FORM APPROVED
OMB NO. 1004-0137
Expires: January 31, 2018**SUNDRY NOTICES AND REPORTS ON WELLS**
*Do not use this form for proposals to drill or to re-enter an abandoned well. Use form 3160-3 (APD) for such proposals.*5. Lease Serial No.
NMNM110829

8. Well Name and No.
JITTERBUG FEDERAL 29. API Well No.
30-015-37491-00-S110. Field and Pool or Exploratory Area
MALAGA11. County or Parish, State
EDDY COUNTY, NM**SUBMIT IN TRIPLICATE - Other instructions on page 2**

Permanent Abandonment of Federal Wells
Conditions of Approval

Wellbore Schematic
Well Name: JITTERBUG FEDERAL 2
30-015-37491

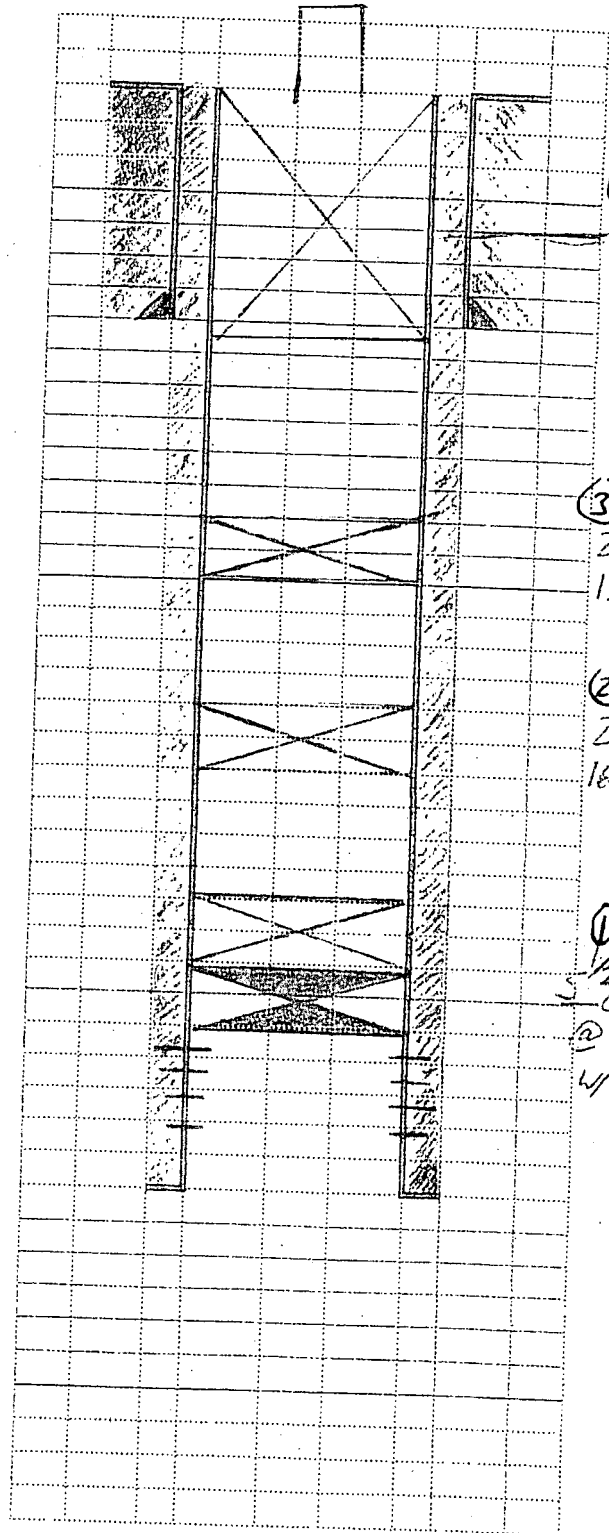
- 1) 5 1/2 CIBP @ 2650' w/35sx cmt. *woc tag*
2) 20sx 1650' - 1550' *25 sx min*
3) 20sx 1250' - 1150' *25 sx min woc tag*
4) 50sx 471' - Surf. Verify. Install DHM.

Record indicate both strings circulated.
P&A mud between all plugs.
Close loop all plugs to licensed facility.
